COLORADO DIVISION OF RECLAMATION, MINING AND SAFETY
MINERALS PROGRAM INSPECTION REPORT
PHONE: (303) 866-3567

MINE NAME: Cresson Project	MINE/PROSPECTING ID#: M-1980-244	MINERAL: Gold	COUNTY: Teller
INSPECTION TYPE: Monitoring	INSPECTOR(S): Elliott R. Russell	INSP. DATE: April 28, 2016	INSP. TIME: 10:30
OPERATOR: Cripple Creek & Victor Gold Mining Company	OPERATOR REPRESENTATIVE: Marc Tidquist	TYPE OF OPERATION: 112d-3 - Designated Mining Operation

Photo 9. Significant amount of process slurry material within the secondary containment concrete foundation; looking northeast.

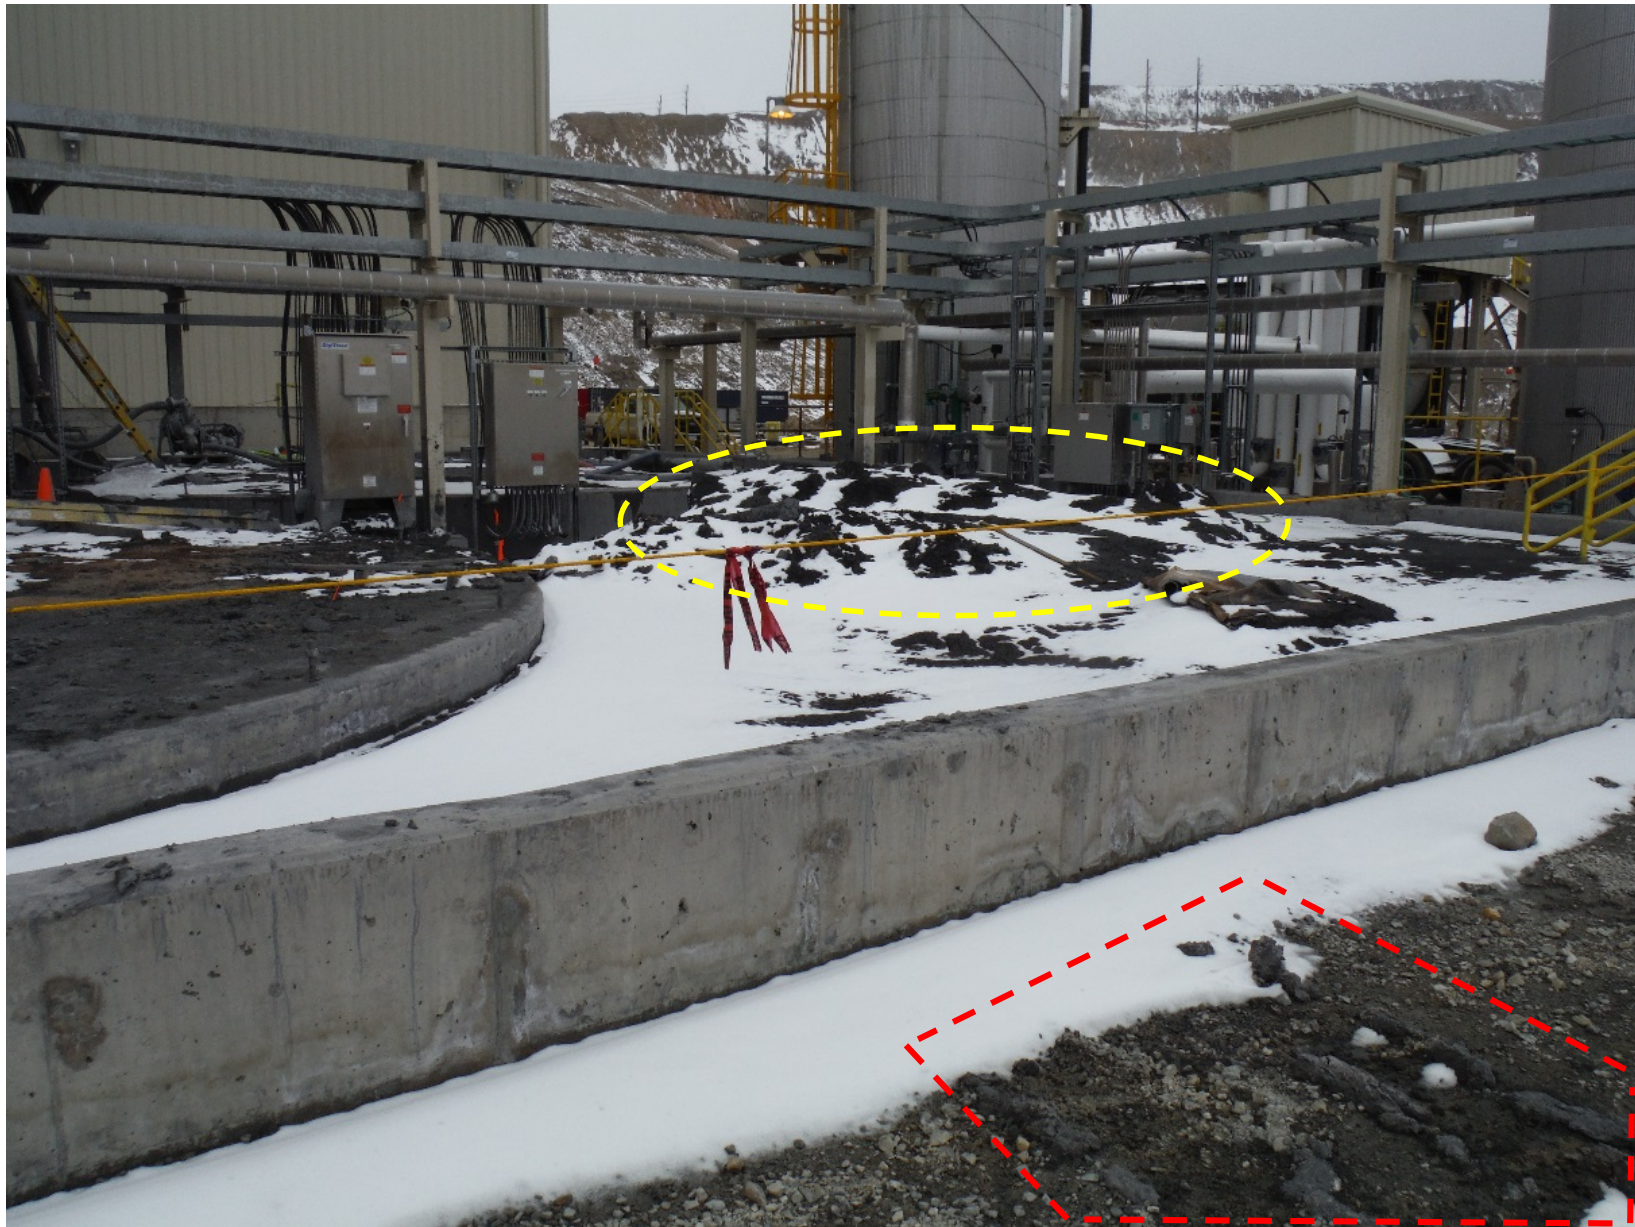
Following up with previous observations, the Division inspected the southwest corner of the HGM pad where a seep/possible discharge was observed coming from the edge of the HGM pad liner. These areas of concern were dry at the time of the inspection (**Photo 5**). The Division observed gray staining on the surface grate of the western most sump (sump CB-3) of the HGM pad liner and a corroded metal pipe (**Photos 6 & 7**). It appears that metallurgical processing solution was possibly drained into the HGM sump. The Division observed gray staining on the sides of cyanidation vat leach tank #1 and the side of the nearby building located on the west side of the HGM (**Photo 8**); it appears this tank was overtopped with process slurry and splattered on the adjacent building. Evidence of splatter on the entire height of the adjacent building, approximately 30 feet tall, was observed. The Division observed a large amount of processed material inside the curbed concrete foundation, consuming the capacity of the secondary containment of the cyanide vat leach tanks. This solid material was dark gray in color and consistent with the characteristics of the mill's process slurry. The approved permit discusses that the process slurry associated with the vat leach process is comprised of a dilute sodium cyanide solution, lime, and the fine concentrate slurry which had been floated through the mill's froth floatation process. There are six vat leach tanks, each are approximately 173,000 gallons in size and the curbed concrete foundation has the capacity of 75% of one vat leach tank. The Division observed that the secondary containment was filled to within approximately 6 inches of the top of the curbed foundation (**Photo 9**). A large amount of this material was heaped up in the southern end of the secondary containment, between the foundation for future leach tank #7 and the leach area sump #2; it appears the sump as well as multiple electrical junction boxes had been cleared of the slurry residue (**Photo 10**). Observations made during the inspection and recorded in this report indicate the Operator has failed to maintain the secondary containment capacity of the vat leach tanks. This is cited as a part of a Possible Violation, additional details are provided on page two of this report.

The Division observed traces of material outside of the secondary containment structure, which appears similar to the material consuming the capacity of the secondary containment. This material, located outside of the secondary containment vessel, could be related to the cleanout of the sump and electric boxes discussed above. Given the height of the tank and relatively short height of the curbing, the pattern of splatter observed on the adjacent building indicates material from vat leach tank #1 was broadcast beyond the secondary containment structure (**Photo 11**). The approved permit states that all spills and leaks from the cyanidation leach tanks will be contained within the curbed concrete foundation. The loss of containment at the secondary structure is cited as part of a Possible Violation, additional details are provided on page two of this report.

CORRECTIVE ACTIONS: This possible violation has been scheduled to be considered by the Mined Land Reclamation Board, during the June 22-23, 2016 Board meeting. Official notice of the schedule and other details for the MLRB hearing will be provided under a separate document to be sent via certified mail to the operator. The Operator shall also reestablish the approved secondary containment capacity for the cyanidation leach tanks by the corrective action due date.
